**FINAL REPORT
VALUE ENGINEERING STUDY**

**CDOT Region 2
I-25 North Design Build
El Paso County**

March 2012

BY SOLUTIONS ENGINEERING & FACILITATING, INC.

Alternative 2

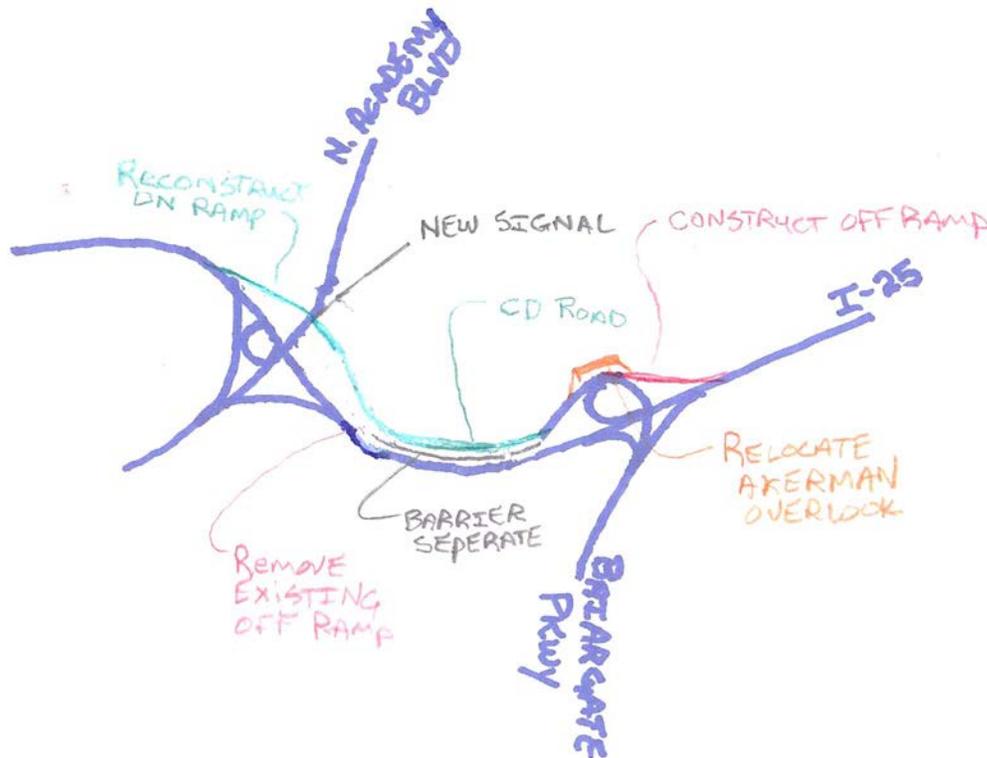
Alternative 2 is the same as the first alternative, except the Academy offramp is relocated north of Briargate. This would eliminate the weave concern presented in the first alternative. With this alternative, The Ackerman Overlook could be relocated from I-25 mainline to the new off ramp. The overlook would be in a location that would provide a better view of the Air Force Academy and would be constructed with safer access that meets current roadway design standards.

Under either of these scenarios, interchange reconfiguration will require an extensive operational analysis to assure that the interchange will function properly opening day and into the future. Reconfiguration of an interchange on a state or federal highway will require a CDOT 1601 process along with an Interchange Access Request (IAR) from FHWA supporting changes to access on an interstate highway. These processes and supporting analysis will take a significant amount of time and would likely delay the overall project schedule. The improvements of the above alternatives, however, could easily be added in the future as clearances are acquired and funding is secured.

Sketch of Concept

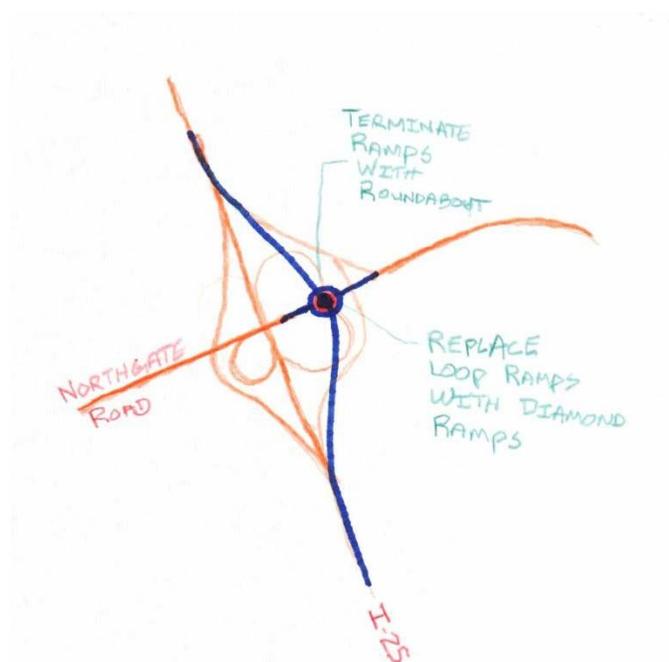
Current proposed action has LOS B at the North Academy interchange ramp intersections. By removing the loop ramps and forcing loop ramp volumes through the signalized intersections, the southbound I-25 ramps become LOS D and the northbound ramps become LOS C. In general, since the roundabouts would have a higher capacity than signalized intersections, theoretically the roundabouts would therefore operate at LOS D or better, and LOC C or better for southbound ramps and northbound ramps respectively. The loop ramps would obviously be removed in the alternative option.

There is limited ROW to construct the roundabouts with adequate radius at the Academy interchange. The Academy interchange provides access to the United States Air Force Academy (USAFA) for deliveries and the roundabout radius; therefore, the AFA easement would need to be increased to accommodate trucks. This would probably encroach on the USAFA easement boundary. The Northgate interchange appears to have room to construct the roundabout with adequate radius.

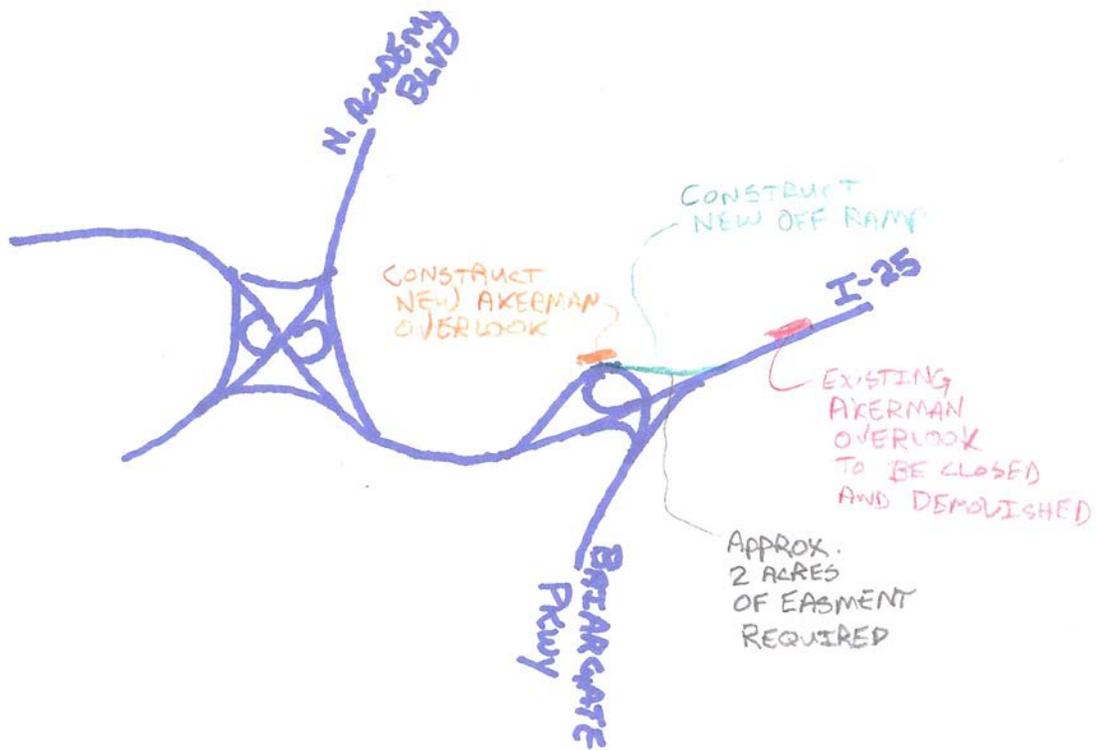
The As-Designed base case condition currently requires that the Ackerman overlook be closed. The current location of the overlook is approximately 1,500 feet north of the Briargate Parkway Interchange, and provides substandard acceleration and deceleration access. This substandard condition poses a safety issue and increase congestion along mainline I-25. It is currently anticipated that a new overlook will be constructed north of the existing in future phases of corridor expansion. There has been public outcry in the past when the overlook was shut down, and it is anticipated that a closure (for any period of time) will not be well received from the public.

Reconfiguration of the Briargate interchange will require an operational analysis to assure that the interchange will function properly opening day and into the future. Reconfiguration of an interchange on a state or federal highway will require a CDOT 1601 process along with an Interchange Access Request (IAR) from FHWA supporting changes to access on an interstate highway. A re-evaluation of the EA may also be required to support a change in the overlook location. These processes and supporting analysis will take a significant amount of time and would likely delay the overall project schedule. Additionally, the new ramp would require approximately 2 acres of additional easement from the USAFA. This could also add additional time and cost to the project. Constructing the off-ramp and the new overlook however could easily be added in the future to the As-Designed base case condition with little or no throwaway.
